September 29, 2025

RE: Columbia Pike Bike Boulevard Concept Plan

I write today with lengthy feedback on the Columbia Pike Bicycle Boulevard Concept Plans presented at the September 18th Open House at Walter Reed Community Center. The proposed plan fails to meet the needs of the Columbia Pike Community. It suffers from several high-level issues that pervade the entire plan, including:

Pike Neighborhoods Plan - SusMo annotations in red

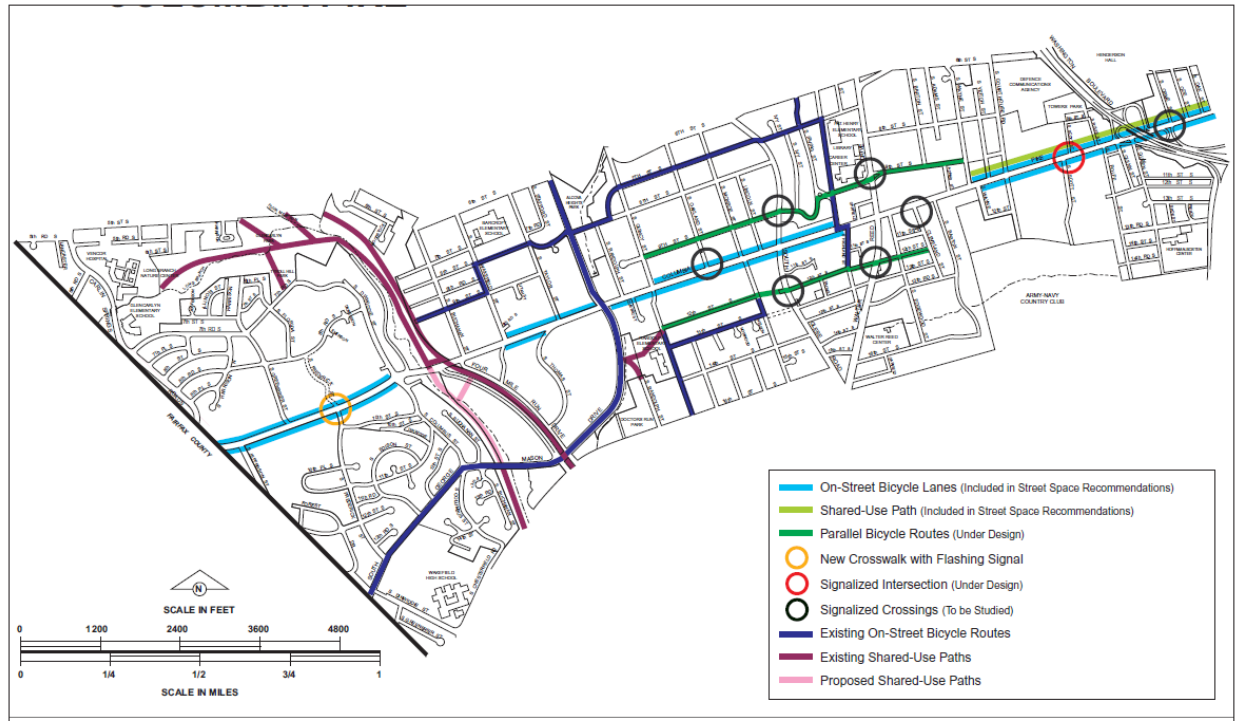
- Greenbrier St (8th Rd to the Pike) - connect to commercial destinations
- Dinwiddie St (8th Rd to the Pike) - connect to commercial destinations

Several of these connections have been expected & notated in Columbia Pike Planning documents (see Appendix A).

Appendix D

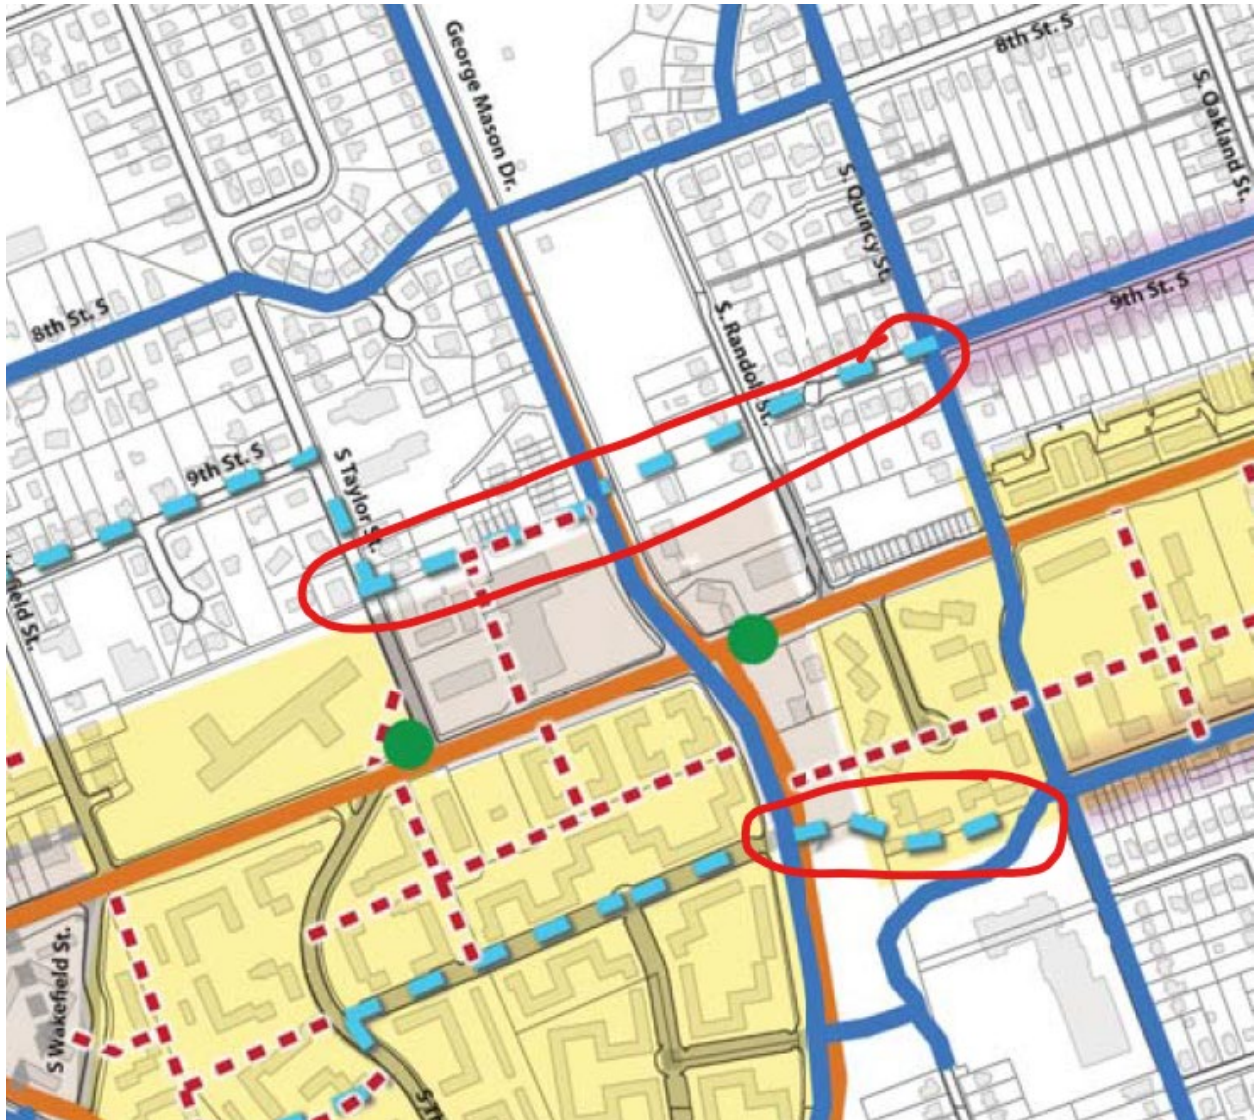
- The significant deviation from the Pike required in order to travel east beyond Wayne St. This was not supposed to be a problem, the Columbia Pike sidepath was supposed to extend west to Wayne Street according to the Columbia Pike Initiative Update (see Appendix B) and was the intent of Pike Multimodal according to several emails from the project manager (see Appendix C), but that does not appear to be what is being built at this time. Solving this now will either require a follow-on capital project to widen the sidewalk between Wayne & Vietch to trail-width, or purchasing two homes to push a trail through between Wayne & Vietch aligning with 9th St (see Appendix D).

Potential long-term solution to circuitous routing to bridge this gap between Wayne and Vietch along the 9th St Bike Boulevard

Appendix E

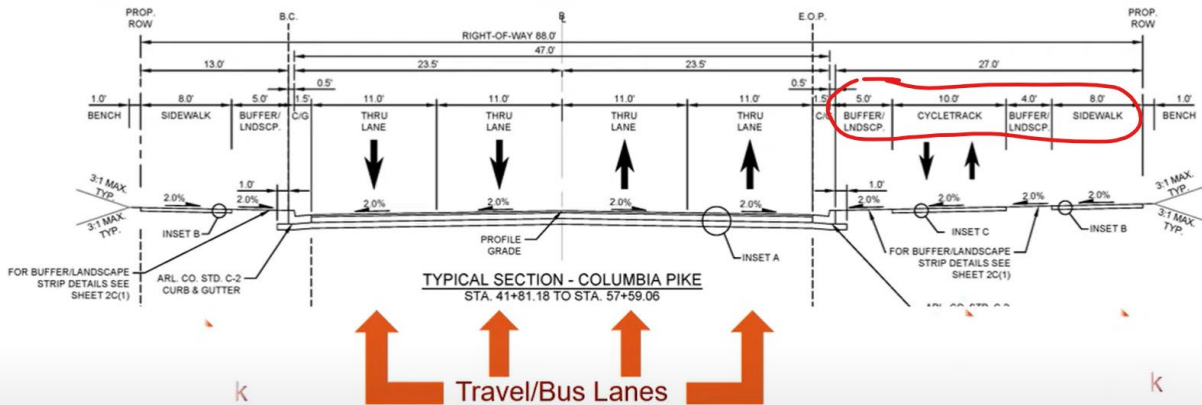
- The significant deviation from the Pike and serious grade along the bike boulevards resulting from detouring all the way up to 8th St to cross George Mason Drive. Solving this will likely require a bike/ped bridge connection over George Mason Drive, between Taylor St and the dead end of 9th St between Quincy and Randolph. This connection is envisioned in the Columbia Pike Neighborhoods Plan (see Appendix E)

Pike Neighborhoods Plan, showing expected new connections: a bridge over George Mason Drive linking Quincy to Taylor and a new trail along the north edge of Doctors Branch Park. Annotations by SusMo in solid red

Appendix G

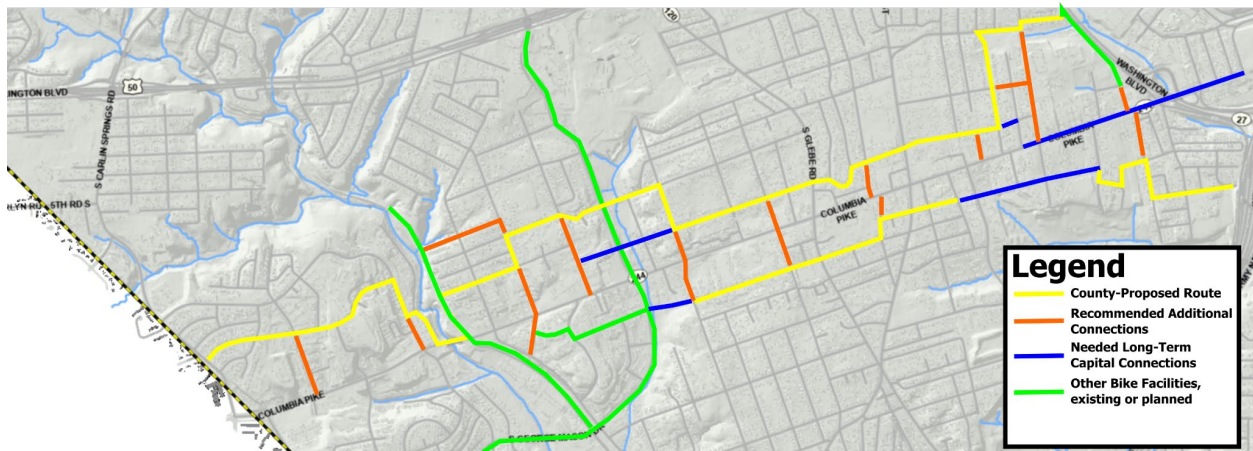
We have added this feedback via the County’s survey & mapping tool to the extent possible, but wanted to also present a more unified letter with more space for reasoning, context, and citations. Furthermore, the county’s survey offers no place to provide overall feedback, outside of answers to very specific questions, or specific locations on the map. We have also included a marked-up overview map with our recommendations as Appendix G, in case it is helpful.

Illustration of proposed improvements to County concept plan, by SusMo
